PLANNING, ZONING, & BUILDING DEPARTMENT  
PZ&B Staff Combination Memorandum: Architectural Commission and Town Council

SUBJECT: ZON-24-046 (ARC-24-040) 227 ANGLER AVE (COMBO)

MEETING: APRIL 24, 2024 ARCOM  
MAY 15, 2024 TOWN COUNCIL

The applicant has submitted plans, entitled "Demolition of Existing Pergola, Replacement with Loggia, 224 Angler Ave" as prepared Kirchhoff & Associates Architects, dated April 8, 2024.

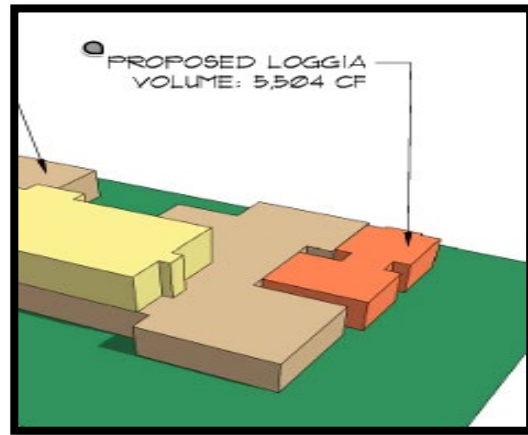
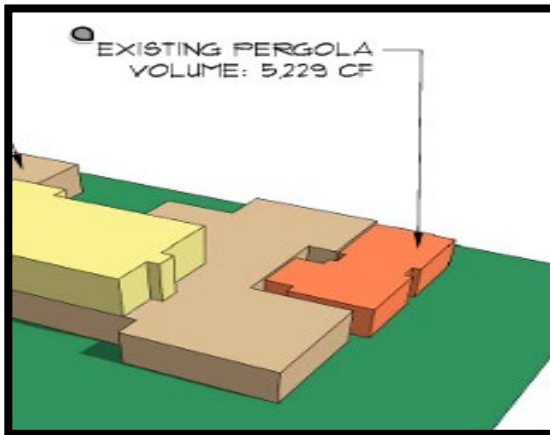
The application is for the construction of an enclosed loggia at the rear of an existing two-story residence. A preliminary review of the project indicates that the application, as proposed, is **inconsistent** with the Town zoning code and requires two variances (1) variance to exceed the allowable lot coverage and (2) variance to exceed the allowable cubic content ratio.

Staff notes that the progression from original construction will continue the deficiency in lot coverage and trigger relief from cubic content requirements. Lot coverage prior to the 167 SF awning replacement was 29.61% just under the 30% permitted. In 2020, with the addition of the 565 SF pergola over existing hardscape, the main house with the pergola covered 34% of the lot and the new loggia, although 15 SF less (33.26%) will still exceed allowable lot coverage. The zoning code permits a 5% credit to CCR for unenclosed loggias, pergolas, porches, terraces and covered patios and a 3% lot coverage exemption for awnings or trellises.

The applicant has made note within this application of rainwater/drainage issues with the current structure as well as concerns with their adjacent neighbor. Approval of the proposed loggia and variances would renew the parcels existing non-conformities.

At the March ARCOM meeting the commissioners expressed concern over the required variances to maintain the current deficiencies in lot coverage and CCR. The applicant has resubmitted with revisions including the reduction in column diameter, a redesign in the rafters to match the existing and a metal roof in lieu of the previously proposed wood however the footprint remains the same.
